Item ID: D412-664-209

Item Name: Crosstube Low Standard Aft

DART AEROSPACE LTD		Work Order:	95463
Description: Crosstube Low Aft (412)		Part Number:	D412-664-209
Inspection Dwg: D412-664-249 Rev: B		Page 1 of 1

DRAWING NO. D412-664-249	TITLE CROSSTUBE ASS'Y (412 LOW AFT)	REV. B	DART AEROSPACE LTD ENGINEERING ORDER		D.E.O. NO. D412-664-249-B-1	SHEET NO. SHEET 1 OF 2	SCALE NTS
DRAWN 92	CHECKED SC	MFG. APPR. E	APPROVED MD		DE APPR. MD		
DATE 11.05.25	DATE 11.05.31	DATE 11.05.31	DATE 11/05/31		DATE 11.05.31

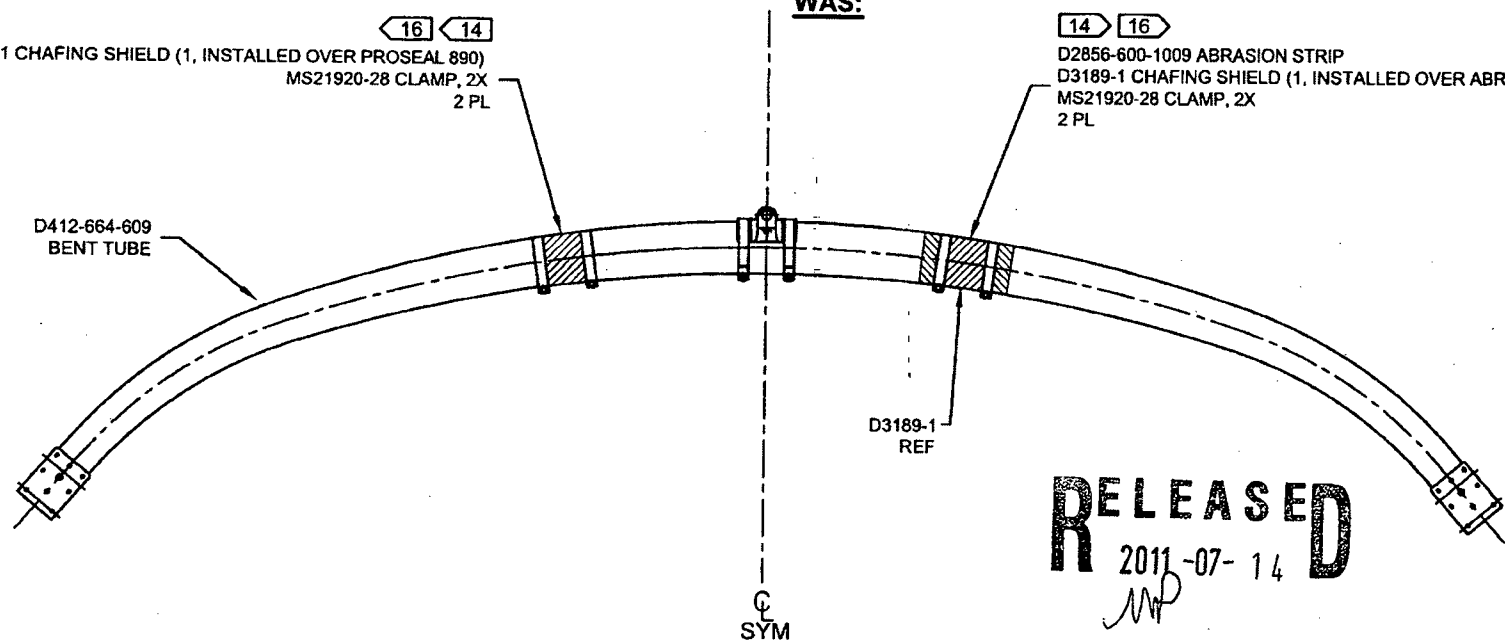
NOTE 14, SHEET 1 IS AMENDED AS FOLLOWS:

IS:

**D412-664-249  
ASSEMBLY DETAIL**

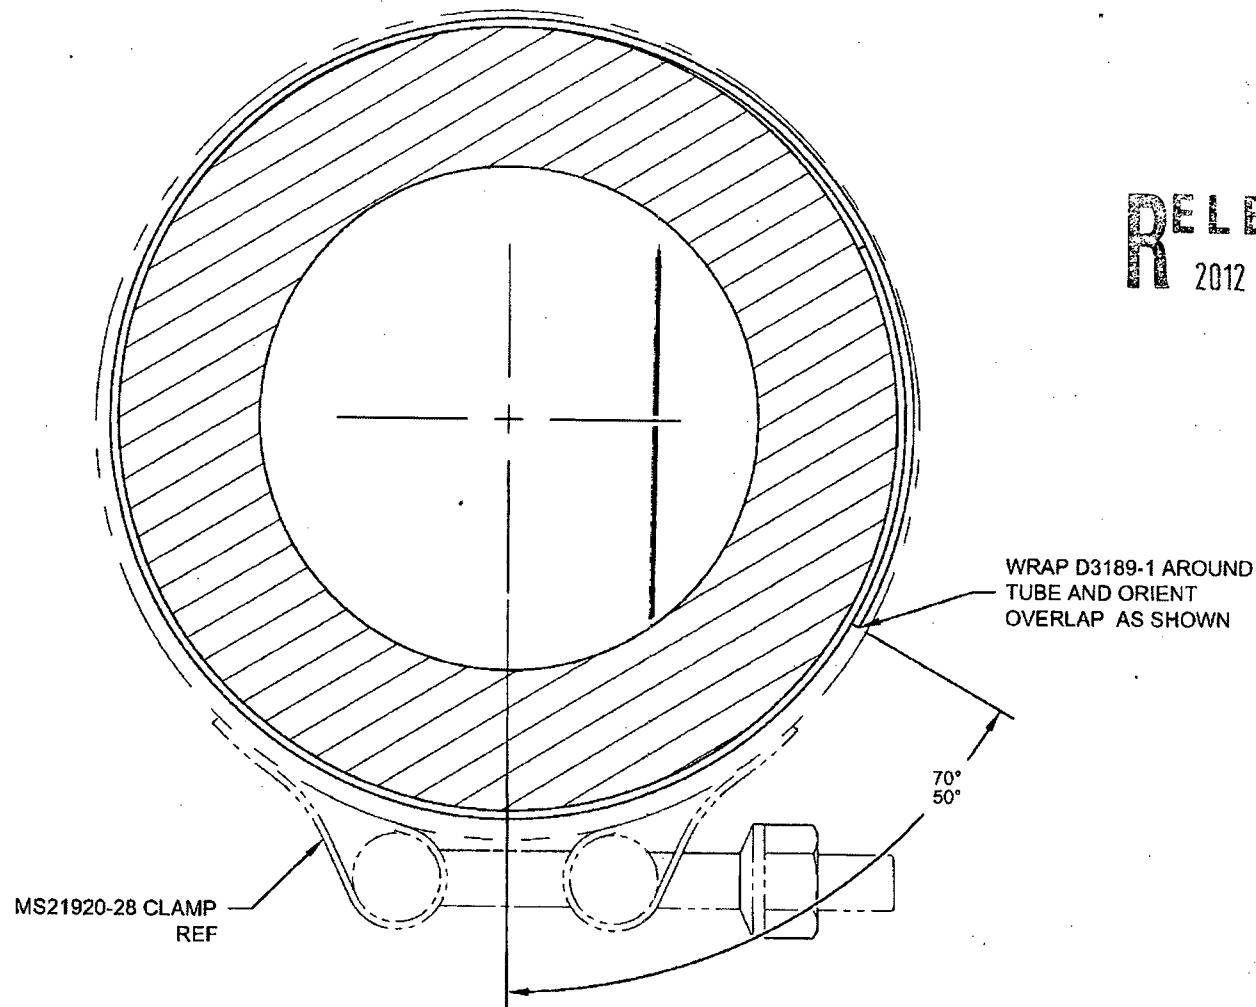
NOTE 14 AND 16 ON SHEET 1 IS AMENDED AS FOLLOWS:
